MEMORANDUM

TO: Muldoon Creek Water District (37-O) File

SUBJECT: Field Visit

On September 9th, Corbin Knowles and I visited Muldoon Creek to inventory water diversions and measuring devices in an effort to gather information to assess compliance with the Department's October 2003 order requiring the installation of control works and measuring devices. Corbin and I met Jim Peterson, Water District 37-O water master, and Mr. Peterson proceeded to show Corbin and I around. The various points of diversion were GPSed, some site tags were installed, photos were taken, and some measurements were made. The following documents our observations during our visit...

Guy Peterson Diversion

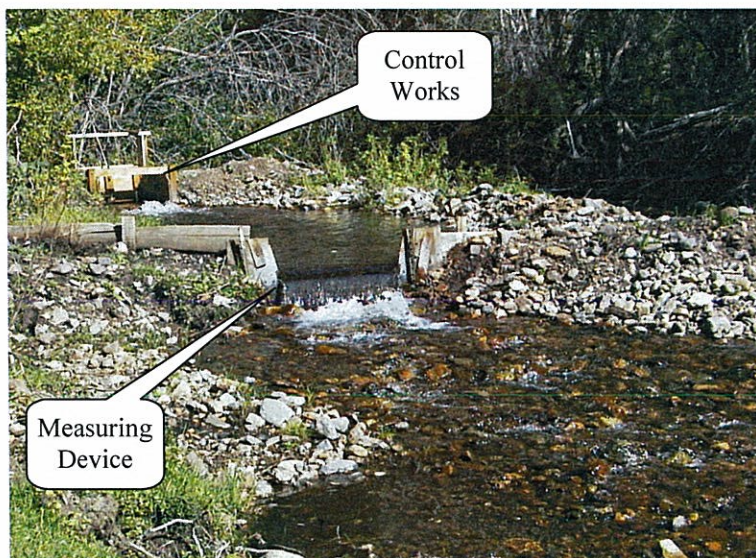
Control works consist of wooden gate structure with wooden gate and metal gate stem. Measuring device consists of a 3.0 foot Cipoletti Weir (metal blade in wood structure). No staff gage was present for the measuring device. Flow through measuring device was measured at 2.16 cfs.

Concerns: Durability of wooden control works and measuring device structure? Lack of staff gage. Guy Peterson's SRBA filing, 37-1143 for 2.8 cfs, identifies point of diversion in Section 24 (T03N, R21E).

Clark Middle Diversion

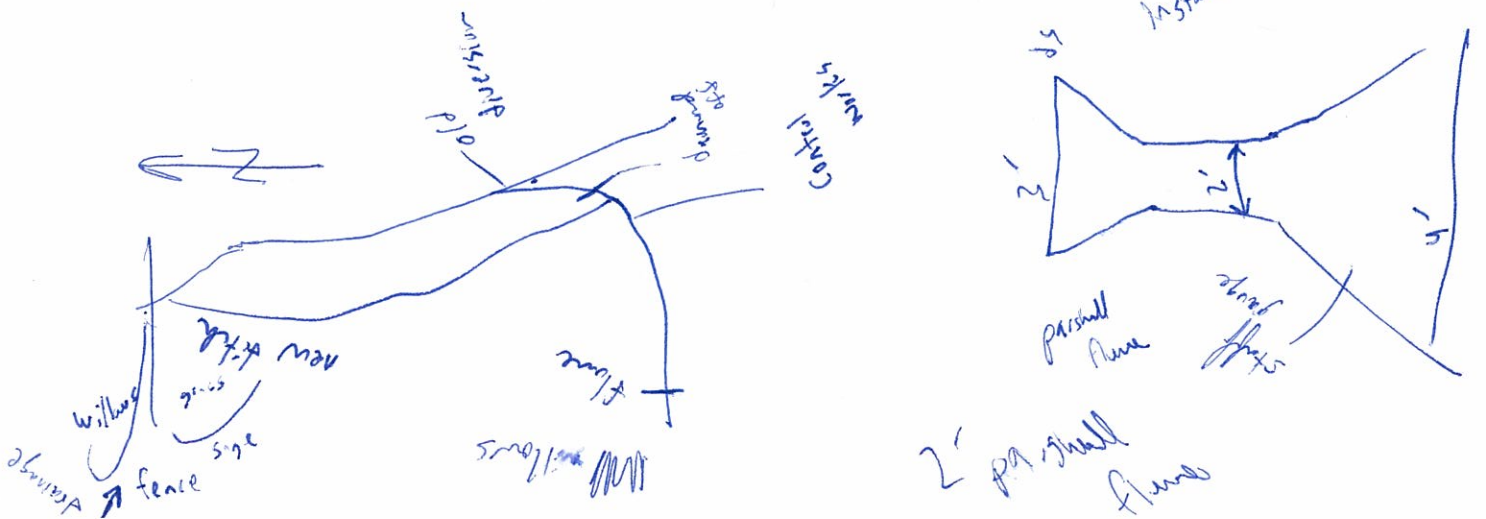
View looking down Muldoon Creek at the head of the Clark middle diversion ditch. Note lack of control works. In addition, no measuring device was present on this particular ditch.

Concerns: No control works or measuring device present. Clark's SRBA filings, 37-1120 and 37-1140, for 7.3 total cfs?, identifies point of diversion in NWSW Section 35 (T03N, R21E).

ABC Agra Middle Diversion

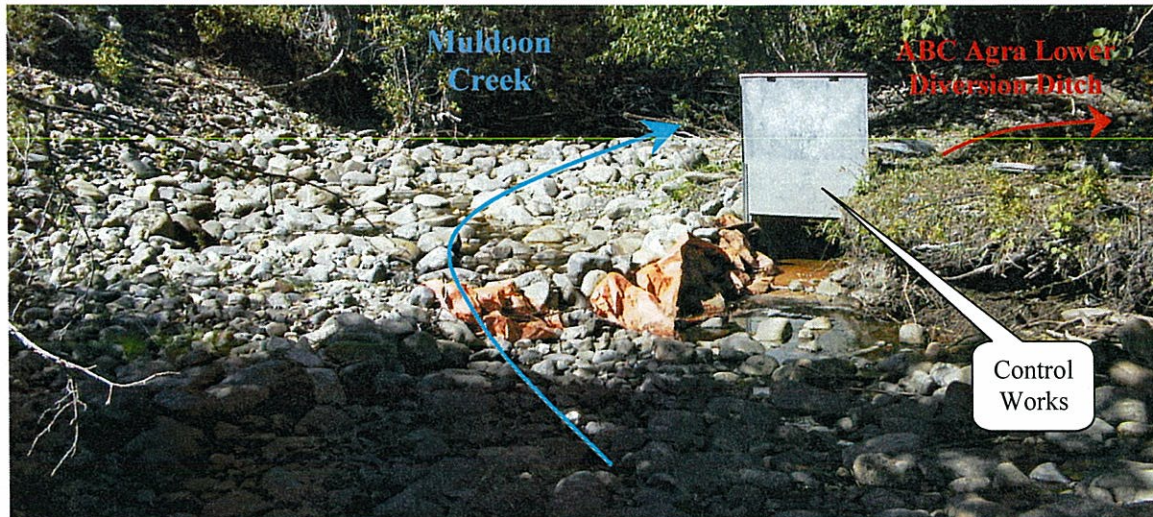
Control works not yet installed. Measuring device consists of a 2.5 foot Cipoletti weir. However the measuring device is located approximately 0.20 mile down the ditch from the diversion point. Flow through measuring device was measured at 1.05 cfs. Only SRBA claim 37-1142 lists this diversion location.

Concerns: Lack of control works. Measuring device located quite a ways downstream from the point of diversion.
